Community Solar Project Interconnection
Community Solar Project System Impact Study Report

**(“Applicant”)
OCS006**

Proposed Point of Interconnection
**Circuit 5W26 out of Enterprise substation at 12.5 kV
(at approximately 45.417905°N, 117.306235°W)**

May 18, 2020

Figure 1: System One Line Diagram

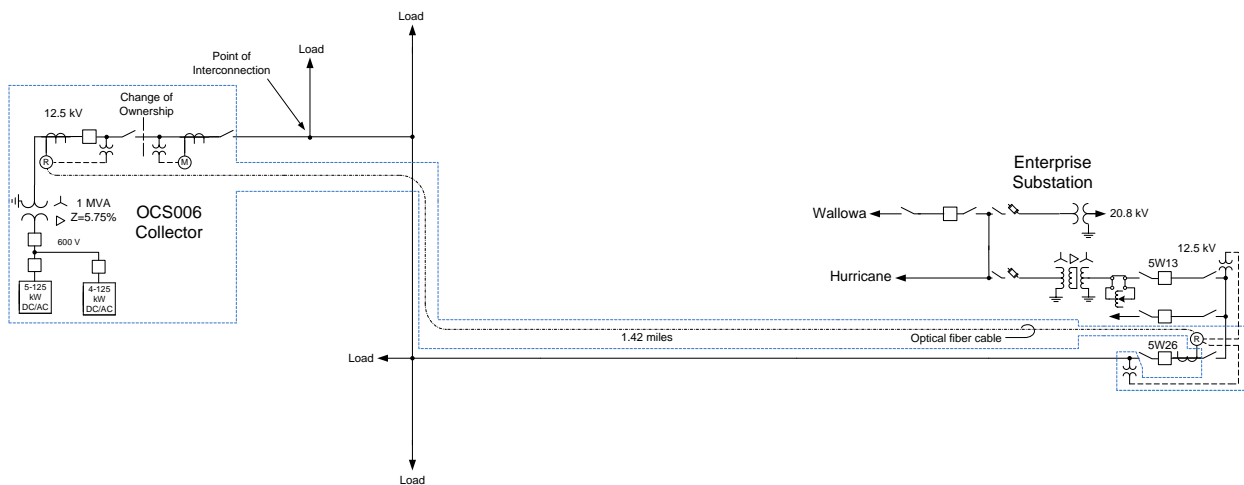
The Applicant's proposed POI is connecting to existing pole identified as map string 01402044.0 and facility point number 033404 1, however this pole is inadequate as it has three 300 amp solid blade cutouts on the pole already. The POI will need to be a new pole located east of the location proposed.

- From the Point of Interconnection to the point of change of ownership the Public Utility will design, procure, and install a line extension consisting of at least three poles. The first pole will be inter-set in the existing Public Utility distribution line, the second pole will hold Public Utility owned and operated gang switch, and on the third pole primary metering units will be installed. Conductor from this primary metering pole will be installed one span to land on the first Applicant owned pole, the termination of this conductor at the Applicant's pole will be the point of change of ownership. The Applicant's final pole shall be constructed to Public Utility standards. The Public Utility facilities will require rights of way obtained by the applicant as required in Appendix 2.
